INDESIT company

BD293G

Commercial code:

F027037

0521100: 20W HEATING ELEMENT FOR DRIP CHANNEL FOAMED TO CABINET

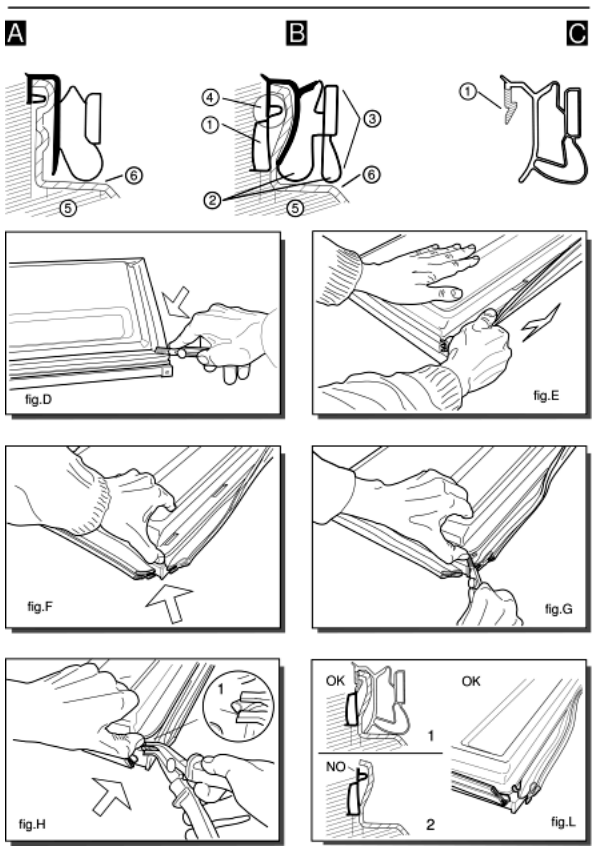
As from serial no. 001110001 the 20W wire heating element on all the 2 and 3 door models of the Nofrost series, including the recessed model, is mounted under the drip tray of the freezer compartment and foamed together with the cabinet.
In the case of heating element failure, use the previous version with the heating element of the drip tray mounted outside (see Service Manual chapter 3.7).

0521124: CLOGGING OF DRAIN HOLE ON NO-FROST FRIDGE

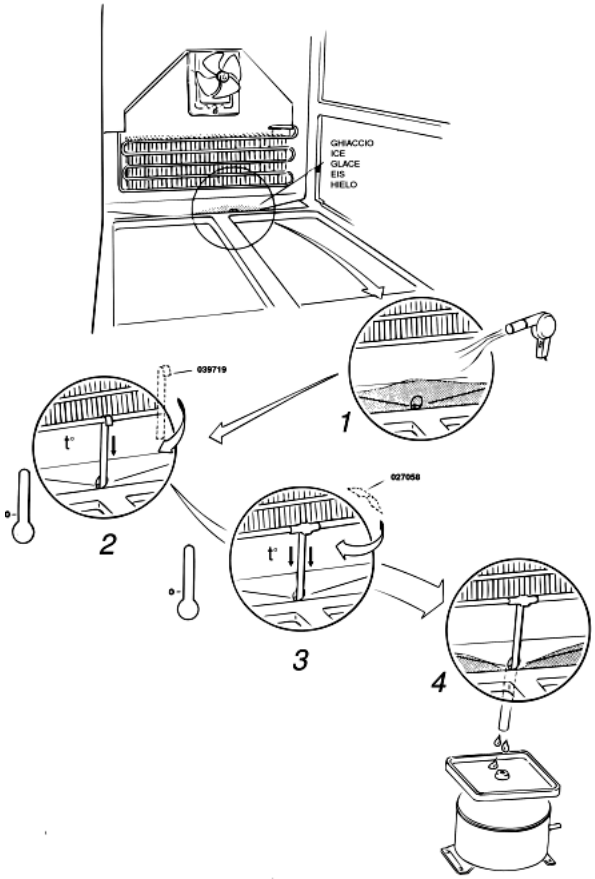
When on no-frost refrigerators at the end of a freezer defrost the ice clogs the drain hole or ducting, do as follows:
--- Check that the 20-W drip heating element is well glued and operative, otherwise replace it.
--- With a hair-dryer remove ice residue and check that the water flows down through the drain hole and to the compressor tray.
--- Insert the aluminium rod (039719) in the hole, the bent end resting on the lowest element of the armoured heating element (60-72 W) mounted on the freezer evaporator.
If the height of the evaporator is less than 9 cm compared to the drip hole, shorten the rod about 3 cm.
To improve distribution of heat inside the drain hole, block the rod on the armoured heating element with a piece of aluminium tape (027058).
The aluminium rod, code (039719), will be equipped with a drawing to explain assembly.
fig.5131539A
A ICE

N130084FIG1

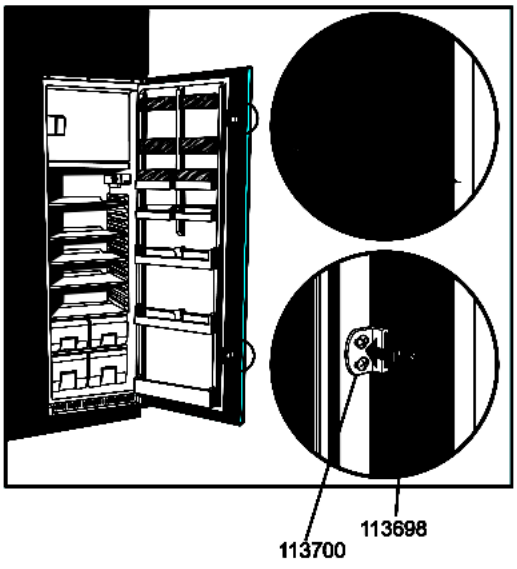
Since October 2004, the Carinaro factory has been using new sliding blocks for fixing the furniture door to the refrigerator door.
The new items are fixed to the side of the refrigerator door, whereas the previous ones were fixed to the front.
The doors are no longer provided with sixteen 2.6 mm holes on the front for fixing the old slides.
The new sliding blocks can also be fitted on premodification models. Proceed as shown in the attached figure (N1030084fig.1).
When replacing the sliding blocks on premodification models it will necessary to replace both guides.
This modification has involved changing the installation KITS
